SUBJECT: "Control of Heavy Loads"
Supplemental Report Addressing
Technical Evaluation Report, Dated August 19, 1982

SUPPLEMENTAL REPORT ON CONTROL OF HEAVY LOADS

RESPONSE TO THE DRAFT TECHNICAL EVALUATION REPORT
PREPARED BY FRANKLIN RESEARCH CENTER CONCERNING
"CONTROL OF HEAVY LOADS - NUREG 0612" AT
R. E. GINNA NUCLEAR POWER STATION

R. E. GINNA NUCLEAR POWER STATION
ROCHESTER GAS AND ELECTRIC CORPORATION
DOCKET NO. 50-244
MARCH 1, 1983

LOCATION OF LONGITUDINAL STIFFENERS IN
THE CONTAINMENT BRIDGE CRANE AS SHOWN
ON WESTINGHOUSE DWG. U-55964.

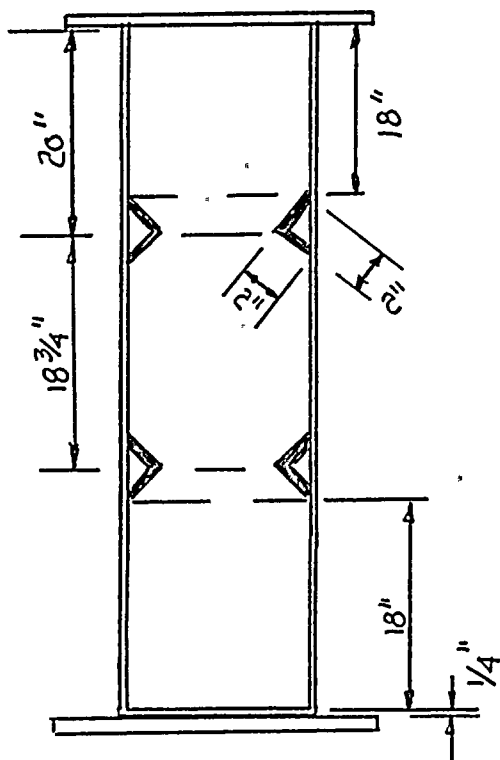
A comparison analysis was done on the containment overhead crane to determine its extent of compliance to CMAA-70. The longitudinal stiffeners are not located as specified in CMAA-70. When two longitudinal stiffeners are used, they shall be located as stated in Section 3.3.3.1.2.2 of CMAA-70. Each shall have a moment of inertia of 2.07 in.⁴ (calculated) the existing moments of inertia are .68 in.⁴ as stated in the "Whiting" crane comparison analysis.

Although not in verbatim compliance with CMAA-70 requirements concerning location and moment of inertia, the use of longitudinal stiffeners in the containment building crane is judged to meet the intent of this guideline. Longitudinal stiffeners are used, in conjunction with transverse stiffeners or diaphragms, to allow the use of thin web plates (i.e., web plates with large h/t ratios where h = web depth, and t = web thickness.) CMAA-70 allows for h/t ratios of up to 188 for girders with no longitudinal stiffener, and of up to 376 for girders with a single longitudinal stiffener. Were such a single stiffener used in the Ginna containment crane, a moment of inertia about the web face of approximately 1.8 in.⁴ would be required. The Ginna design employs two longitudinal stiffeners, each with a moment of inertia of approximately 0.46 in.⁴ about the web face, in conjunction with a web h/t ratio of 236. Although judged to meet the intent of this guideline, the Licensee should provide suitable documentation to justify the location and moment of inertia of the installed stiffeners.

The location of the installed stiffeners in the containment building crane are shown on a Westinghouse Shop Drawing, U-55964 which is a permanent RG&E record. (See attached sketch for stiffener location).

Calculations for the moment of inertia of the stiffeners are shown on pages 15 and 16 of the Whiting Comparison Report (February 1, 1982 submittal, Attachment 5).

The crane girder was designed under EOCI-C1 specifications using sound engineering practices. There is simply no indication that the crane is in jeopardy of structural failure or any overstress due to the location and size of the existing longitudinal stiffeners.
